Response to questions raised by the Stonehenge & Avebury World Heritage Site Coordination Unit in respect of Planning Permission Application PL/2025/00286

The following requests are addressed:

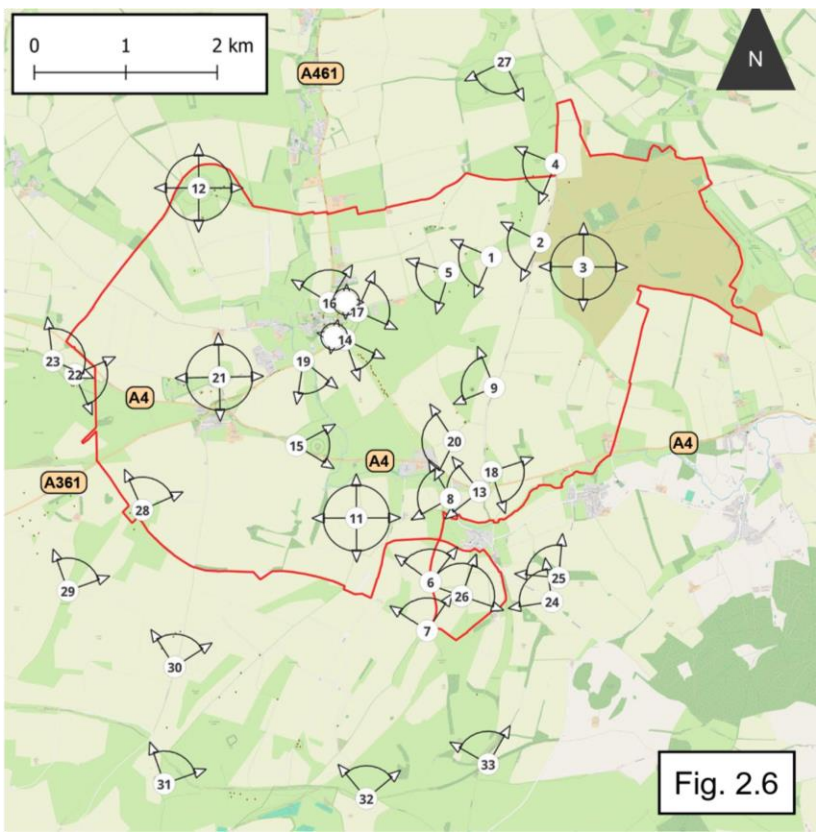
To assess the visibility, three rows of flags were erected in the polytunnel’s planned position in the field, as shown below. These rows ran lengthwise along the site in the same way that the polytunnel is planned to run. The top row of flags is at the maximum height of the polytunnel (2.13 m). The two lower rows are at the height of the vertical walls (0.96 m). These dimensions are as shown below.

Here is an image of the flags in situ.

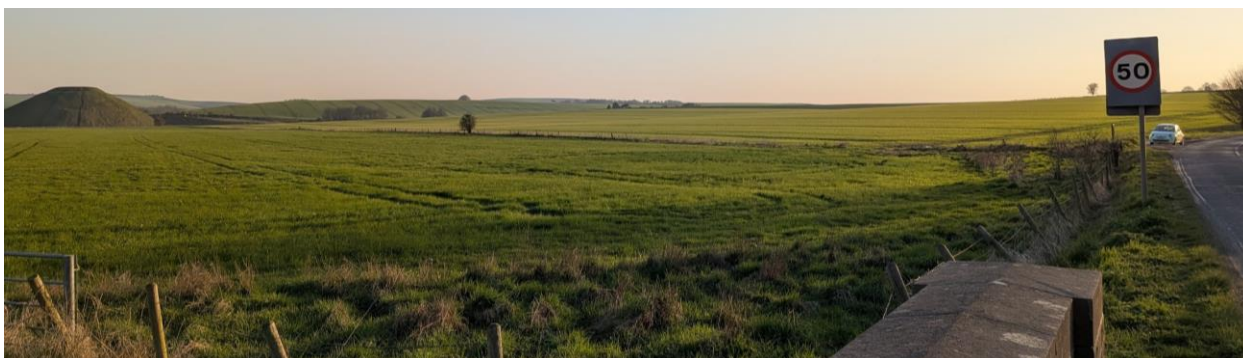
A-VP28 and 29 are significantly further west than the points on the path which I visited, and therefore the effect of the barn obscuring the site would likely be greater at these points. In addition, the high ground between these view points and the site would likely obscure the site.

A-VP30 is significantly further distant (around 4km) and from here the site would likely be obscured by the ridges of land in between, as well as the plantation.

A-VP14

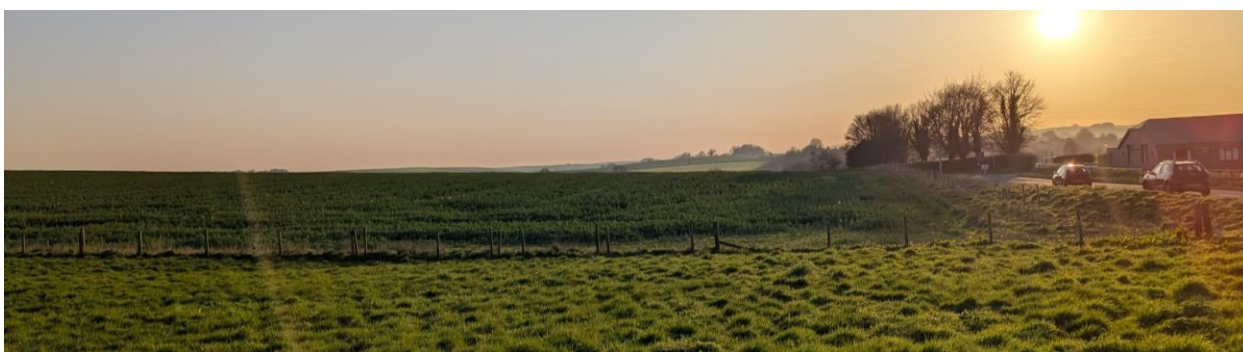
These are views toward the site at various points along the avenue. The site is obscured by the ridge of land to the southwest.
